**Subject: RUNNING CHANGE FOR FLHTK, FLHTCU, FLHTC & FLHTCUTG SEATS  
& BACKRESTS**

# SERVICE BULLETIN

M-1265

## 2010 TOURING MODELS SEAT RUNNING CHANGE

**Figure 1. New Seat Designation (Located On Seat Pan)**

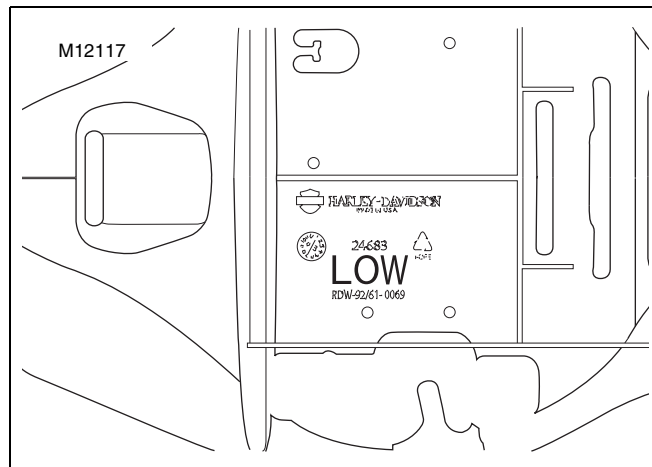
See Figure 1. The later seat will have "LOW" molded into the seat pan to assist in identification. See Figures 2 and 3. Seat changes include a lowered seat height, a narrower nose, and modified stitching. Backrest changes include modified stitching and the removal of pleats. The grabstrap length has increased. Additionally, when a replacement seat is needed, be sure to determine which seat is needed before ordering. Please update all of your information concerning new part numbers for future reference and notify all of your parts and service personnel.
